**APPEAL  
ON BEHALF OF  
SATNAM MILLENNIUM LIMITED**

**IN RESPECT OF  
Land at Peel Hall, Warrington**

**Rebuttal to Rule 6 Party Proof of Evidence (Noise)**

**Date: 26<sup>th</sup> August 2020**

Figure 1: Detailed section of Parameters Plan

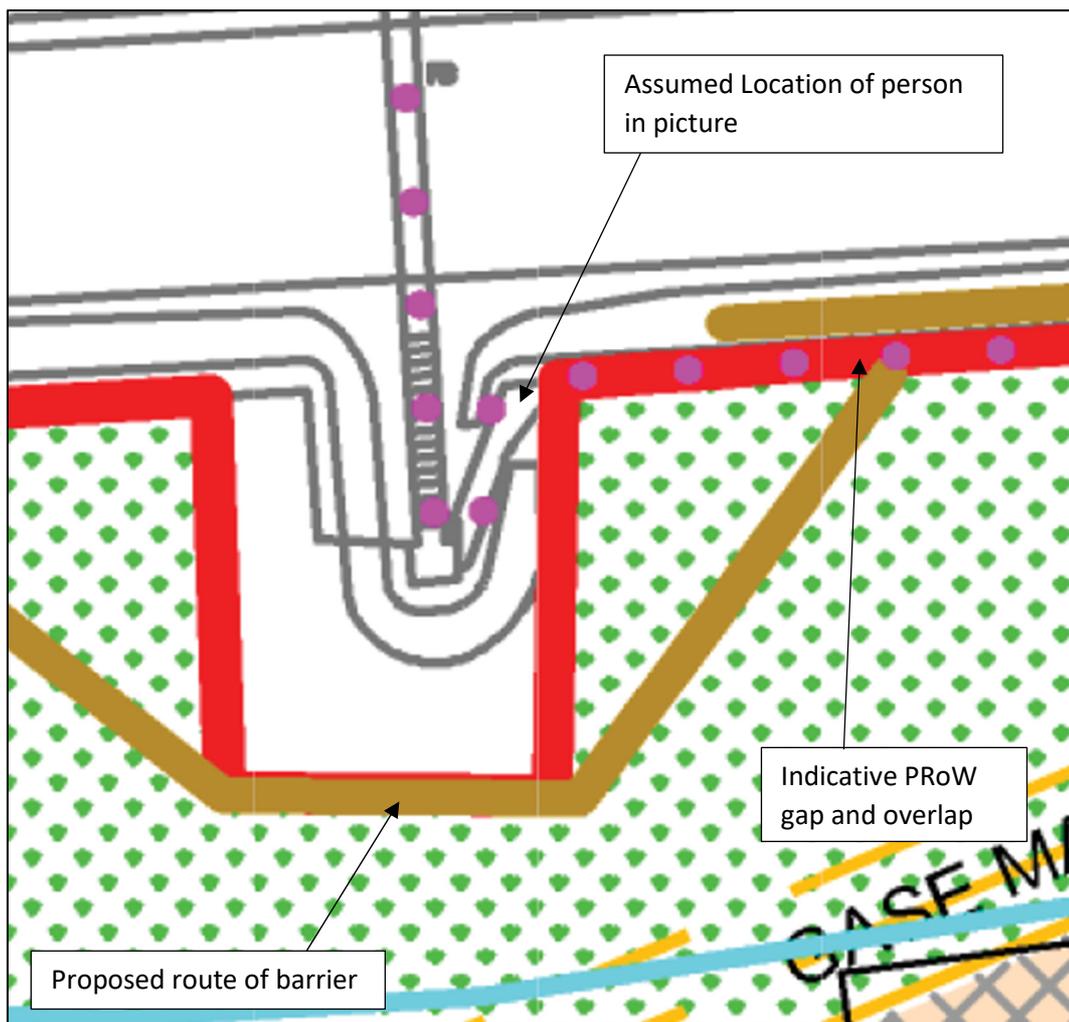
- 4.18. The PRoW has been factored into the design of the barrier as shown on the parameters plan. There is a break in the barrier to allow the PRoW to pass through without deviation. The overlapping design of the barrier will not allow noise to propagate onto the site through the gap created (see figure 1).

- 4.20. At paragraph 4.23, Ms Steen questions the modelling of a vehicle as a transient point source. Noise modelling must assume a busy road as a line source, not a static point.
- 4.21. At paragraphs 4.23 and 4.24 Ms Steen questions how topography of the site is accounted for. As discussed earlier, Lidar topography data is fully incorporated in the model for the site and surroundings.
- 4.22. The height of the barrier is a consistent 4.0 m for its entire length, not 6.5 m as incorrectly extrapolated by Ms Steen. Ms Steen’s figure on Page 26 of her proof which shows a person in relation to the motorway is inaccurate as the acoustic fence would be located to the south and east of this location (see Figure 1)

Figure 2 – Cinnamon Noise Gap, in  $L_{Aeq,16h}$

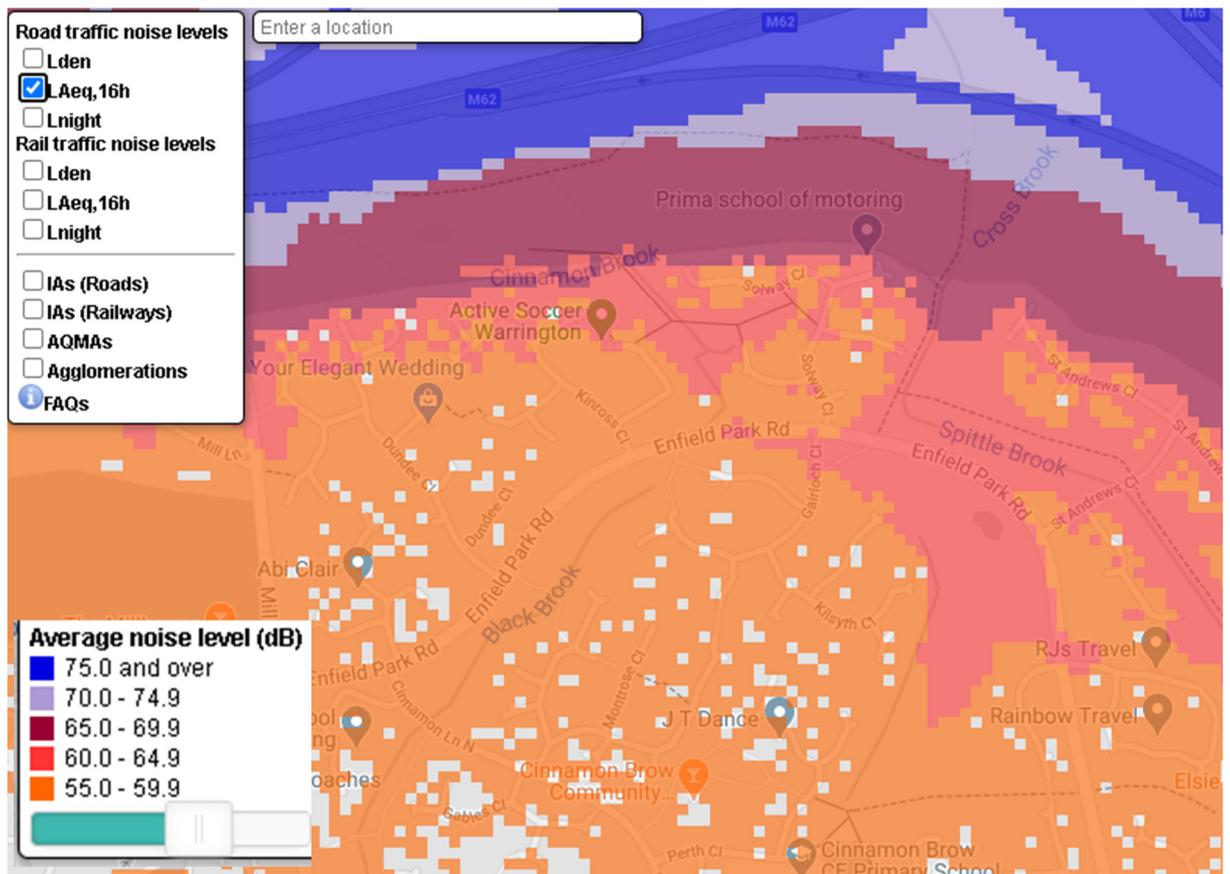
- 5.7. That said, even a 6.5m tall 2 storey detached house demonstrated at Cinnamon Brow is capable of reducing noise to 55-60dB at 4.0m, which will likely be closer to 55dB at garden height. See the map shown in Figure 2 below, which is a reproduction of the map on page 31 of Ms Steen's proof with the appropriate  $L_{Aeq,16h}$  layer highlighted.

Chart 1: Noise levels measured at MP04 from 1600 23/5/19 – 0800 24/5/19

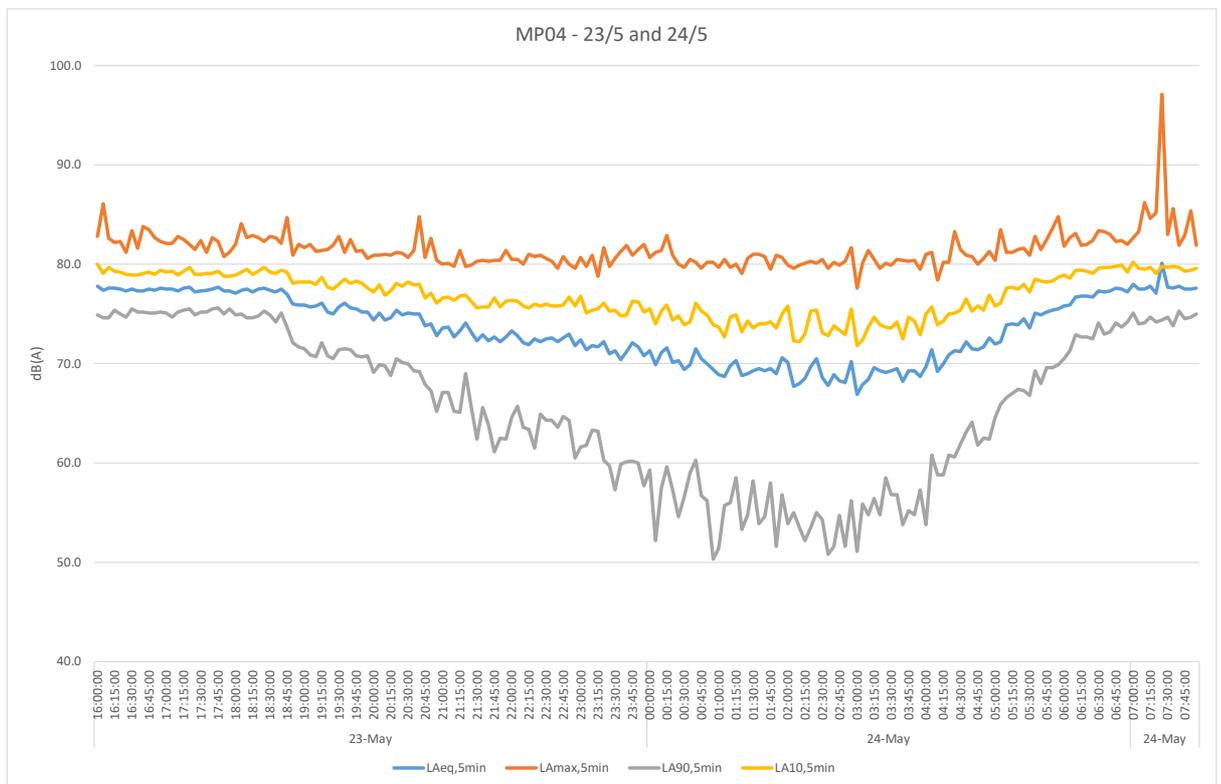
- 8.1. Page 49 of Ms Steen’s proof shows a table of scheduled road closures for maintenance on the M62 around the time of the unattended noise survey.
- 8.2. There is no evidence to show if the scheduled works were actually undertaken and the noise data, including audio recordings clearly demonstrate that the M62 was operational throughout the night.
- 8.3. Chart 1 shows a trace of all the data recorded, with a 5 minute resolution. The stable  $L_{Amax}$  events (orange line) are consistent with free flowing traffic of all classes. The  $L_{Aeq,5min}$  (blue line) data is typical of a free flowing motorway with a minimum between 0300 and 0400, as would be expected on a motorway.
- 8.4. The grey line is  $L_{A90}$ , background noise level and the yellow line is  $L_{A10}$ .

- 8.5. The measured  $L_{Aeq,8hr}$  of 72dB between 2300 and 0700 is what would be expected for a measurement at the side of an operational motorway overnight and also corresponds well with the predicted noise level from DEFRA noise mapping shown in Figure 3.

- 8.6. Whilst ongoing maintenance works may have been scheduled for the night on the 23<sup>rd</sup> May, the data clearly demonstrates that the motorway was open and operational with levels measured being similar to those expected.
- 8.7. In my professional opinion the data is appropriate for its purpose.
